Work Order ID 96783

Item Name: Replacement Skidtube

DESIGN	#	DART AEROSPACE LTD	
DRAWN	RF	HAWKESBURY, ONTARIO, CANADA	
CHECKED	10	DRAWING NO.	REV. E
MFG. APPR.	10	D2580	SHEET 3 OF 8
APPROVED	10	TITLE	SCALE
DE APPR.	10	205 SKIDTUBE ASSEMBLY	NTS
DATE	11.06.21	COPYRIGHT © 1996 BY DART AEROSPACE LTD	
THIS DOCUMENT IS PRIVATE AND CONFIDENTIAL AND IS SUPPLIED ON THE EXPRESS UNDERSTANDING THAT IT IS NOT TO BE USED FOR ANY PURPOSE OR COPIED OR COMMUNICATED TO ANY OTHER PERSON WITHOUT WRITTEN PERMISSION FROM DART AEROSPACE LTD.

DRAWING NO. D2580	TITLE 205 SKIDTUBE ASSEMBLY	REV. E	DART AEROSPACE LTD ENGINEERING ORDER	D.E.O. NO. D2580-E-1	SHEET NO. SHEET 1 OF 1	SCALE NTS
DRAWN <i>UP</i>	CHECKED <i>ASS</i>	MFG. APPR. <i>ER</i>	APPROVED <i>[Signature]</i>	DE APPR. <i>[Signature]</i>		
DATE 11.12.13	DATE 11.12.13	DATE 11.12.13	DATE 11.12.13	DATE 11.12.13

D2580-041 ASSEMBLY DETAIL

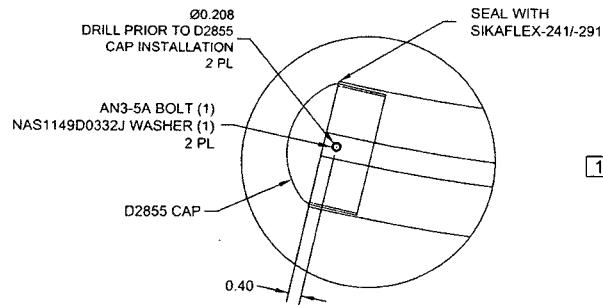
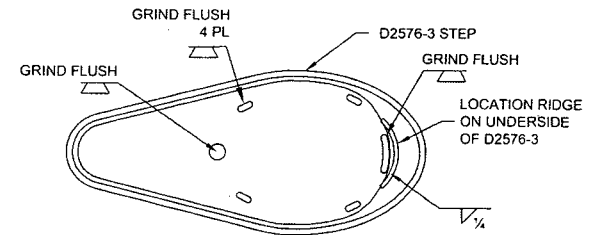
AFTER DRILLING AND BENDING ASSEMBLY
PERFORM THE FOLLOWING FOR Ø0.508 HOLES ONLY:
1. CHAMFER HOLE 0.050 X 45°
2. INSERT D2579 SPACER (20 PLACES)
3. WELD INTO PLACE AND GRIND FLUSH
4. C'BORE D2579 SPACER TO Ø0.437 X 1.00 DEEP

CHANGE ALL C'BORED WELDED CROSSBOLT SPACERS TO SWAGED SPACERS

SECTION B-B, SECTION F-F, & SECTION I-I ARE AMENDED AS FOLLOWS
FOR ALL HOLES THAT WERE ORIGINALLY C'BORED:

D2580-045 ASSEMBLY DETAIL

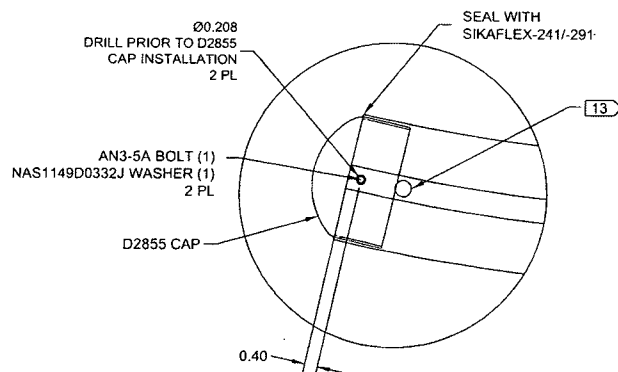
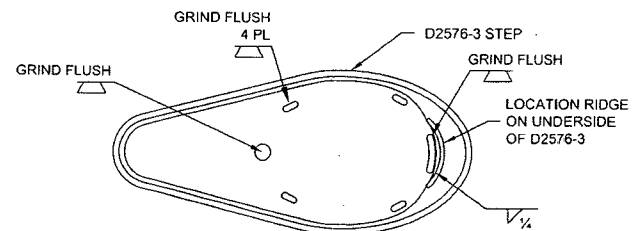
AFTER DRILLING AND BENDING ASSEMBLY
PERFORM THE FOLLOWING FOR Ø0.508 HOLES ONLY:

1. CHAMFER HOLE 0.050 X 45°
2. INSERT D2579 SPACER (24 PLACES)
3. WELD INTO PLACE AND GRIND FLUSH
4. C'BORE D2579 SPACER TO Ø0.437 X 1.00 DEEP

D2580-047 ASSEMBLY DETAIL E

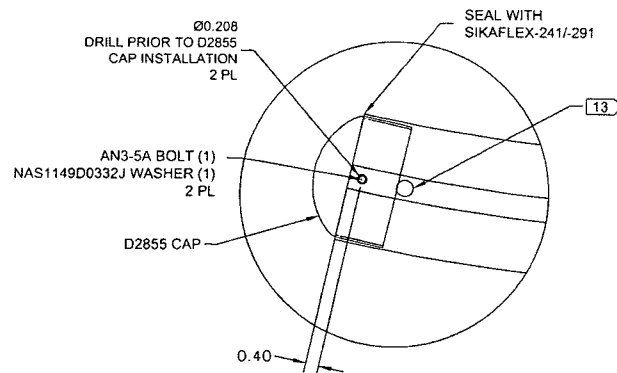
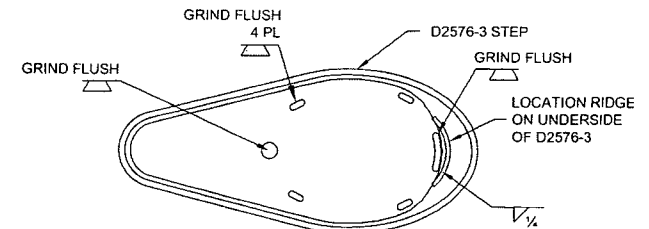
AFTER DRILLING AND BENDING ASSEMBLY
PERFORM THE FOLLOWING FOR Ø0.508 HOLES ONLY:

1. CHAMFER HOLE 0.050 X 45°
2. INSERT D2579 SPACER (25 PLACES)
3. WELD INTO PLACE AND GRIND FLUSH
4. C'BORE D2579 SPACER TO Ø0.437 X 1.00 DEEP

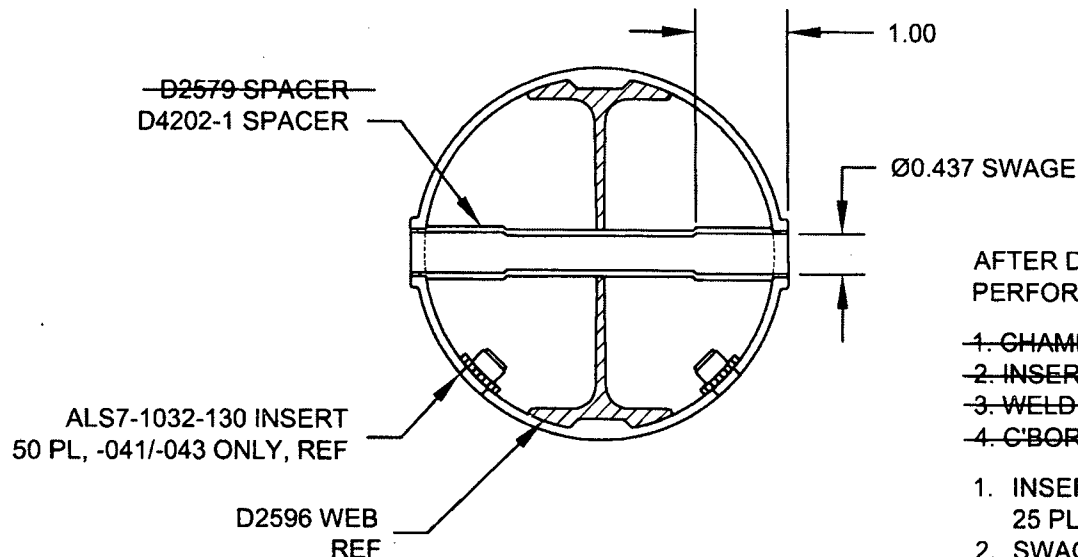
4		* D2579	CROSS BOLT SPACER
20	20	25	D4202-1	SPACER

*** FOR -045 SKIDTUBE ONLY:**

WELD 4X D2579 SPACERS PER DWG
IN LOCATIONS MARKED "NO C'BORE".
REF SHEET 4 OF DWG.
